**BMW Motorrad
USA
Service Information Bulletin**

****Notice of recall 10V-328****

Subject: Retrofitting Arrester Cables for Left Siren Speaker

Model: R 1200 RT-P (K26, 0388) with option code 0113 Authority equipment package.

Work item: 00 60 231 Installing arrester cables.

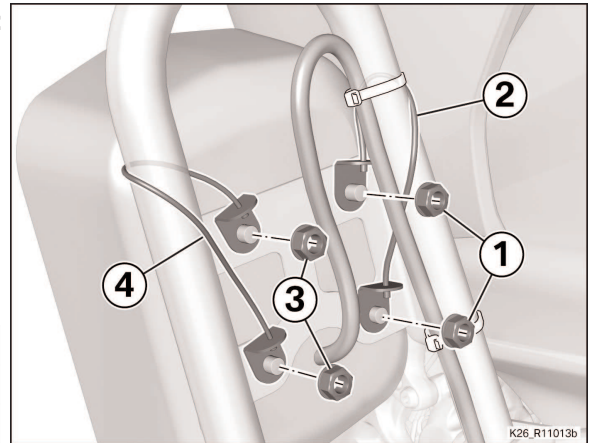
Details: Under extreme dynamic loading when the motorcycle is being ridden, the bracket of the siren loudspeaker on the left protection bar can break. In order to keep the siren speaker safely attached to the motorcycle if the bracket breaks, 2 arrester cables are attached to the siren speaker and the left protection bar.

Production Solution: The Authority units built in the future will be fitted with protection bars (left and right) of a new stronger siren speaker bracket design.

Securing siren speaker with arrester cables:

- Remove nuts (1).
- Hold arrester cable (2) in position and locate it with nuts (1).
- Remove nuts (3).
- Hold arrester cable (4) in position and locate it with nuts (3).
- Tighten nuts (1) and (3) alternately.

Tightening torques	
Siren speaker to protection bar	
1/4" - 20 UNC	8 Nm

Because of the nature of how the speaker will settle into place, it is necessary to apply the torque sequence 4 times.
